**RE: INTERIM AUDIT ADVICE LETTER NO. 1 - 11-13 PERCY STREET,  
AUBURN NSW**

Ref 318000944

Woolworths propose to redevelop the site as a Customer Fulfillment Centre (CFC) which will comprise a single storey warehouse and distribution centre for online sales. The site has a history of industrial use with previous occupiers including a plastics packaging facility and a white goods manufacturer. Filling of portions of the site is likely to have occurred to achieve current site levels. The site is currently occupied by two large warehouses: one of which is used for storage by a stage lighting supplier; and one occupied by a Holden new vehicle accessories and auto detailing service centre.

Investigation Locations  
11-13 Percy Street, Auburn NSW  
00030196  
**FIGURE 3**

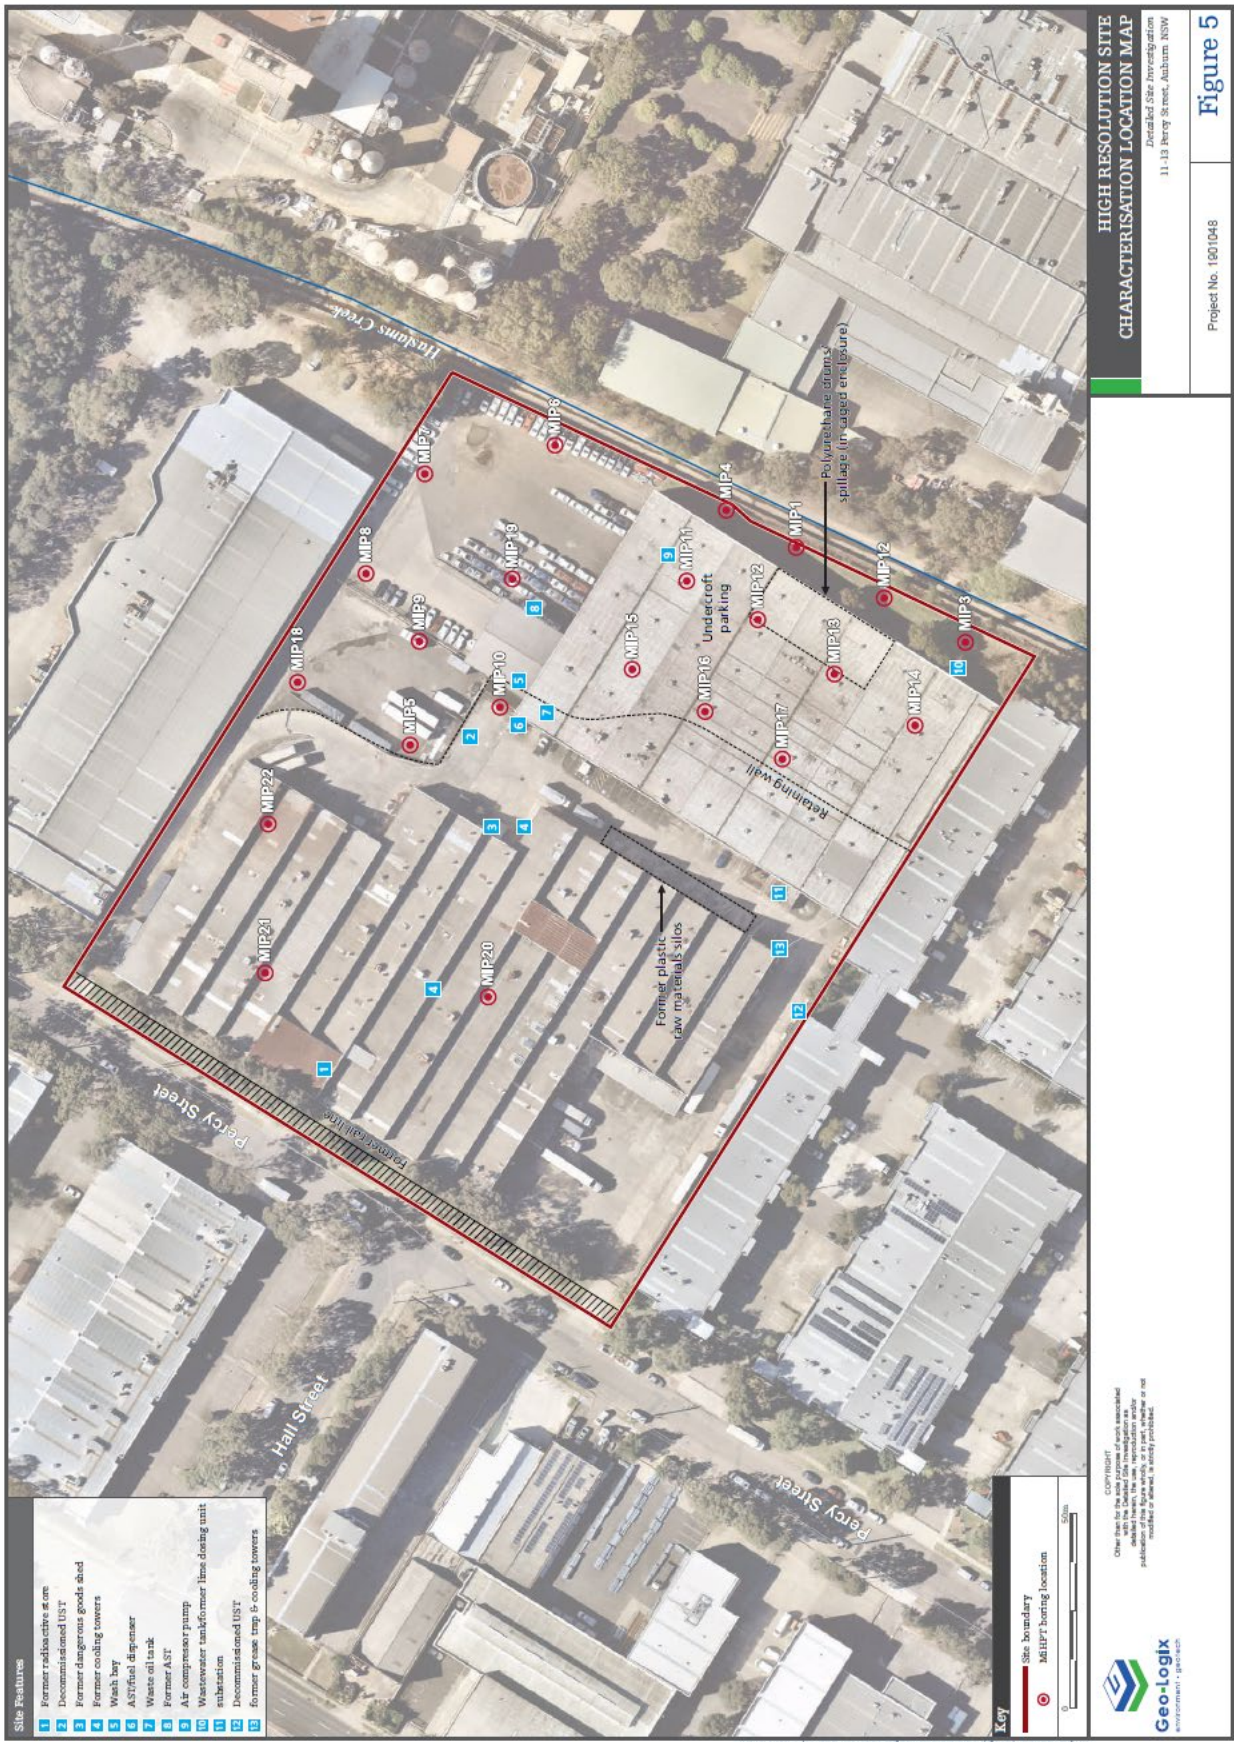
- 1. Additional assessment to confirm that there is no on-site source of TCE in the vicinity of well MW102.*
- 2. Additional assessment of the potential vapour intrusion risk to on and off-site receptors from chlorinated hydrocarbon concentrations in groundwater on-site. The assessment should include the potential for preferential pathways for vapour migration and temporal considerations.*
- 3. Preparation and implementation of a Remediation Action Plan (RAP) outlining the removal and validation of the identified USTs and the ACM identified at the site surface and in shallow soils by Geo-Logix. The RAP*

# Attachment 2: Proposed Development Plan

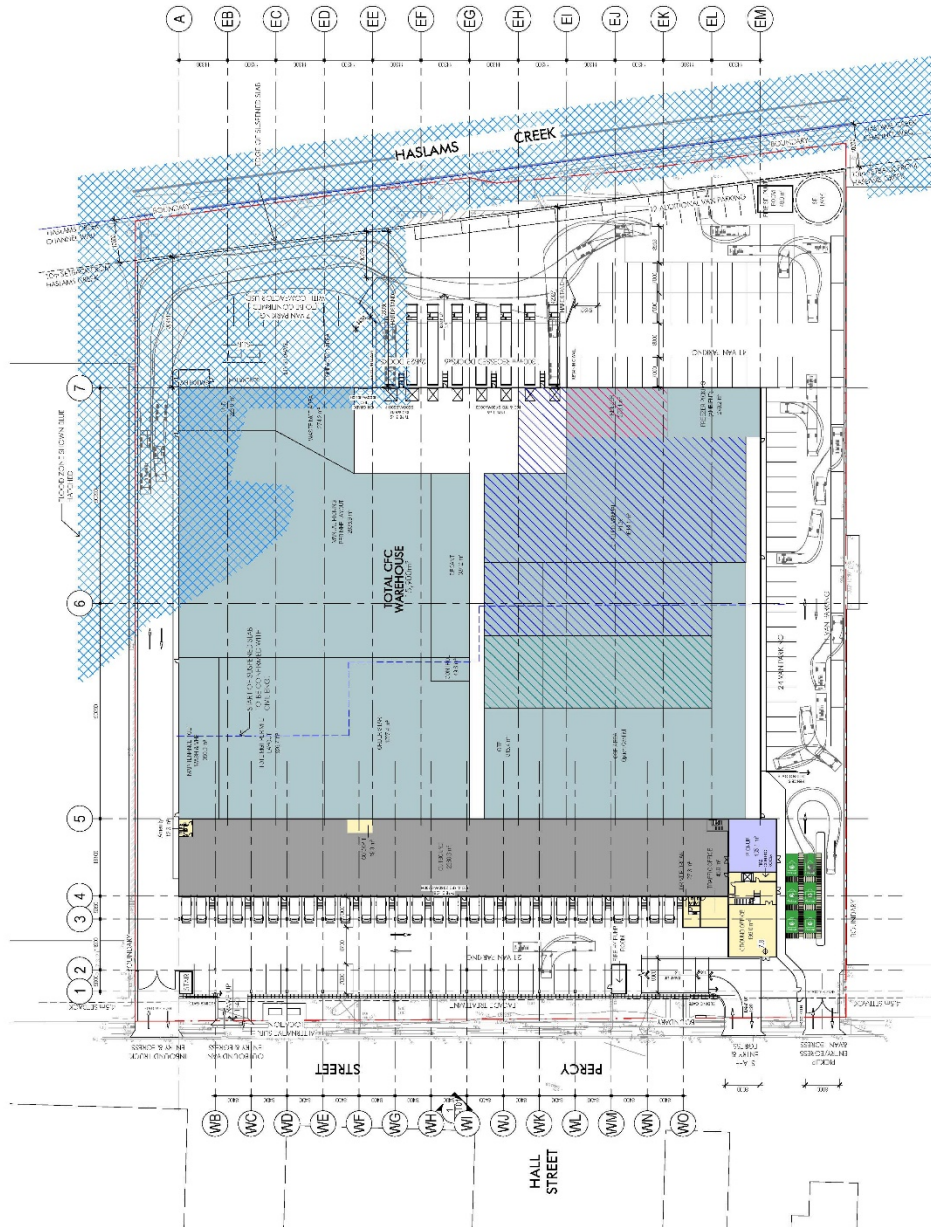
It is noted that since the preparation of IAA No. 1, the development design for the CFC has been amended such that there is no enclosed basement level in the south-eastern portion of the site and the building design in this area will be suspended slab with an open and unoccupied area below the suspended slab (the undercroft). The revised design plan is provided in Attachment 2.

2. Section 2. This section would benefit from a sub-section describing the proposed development and reference development plans included in an Attachment so that the location of the suspended slab can be defined.
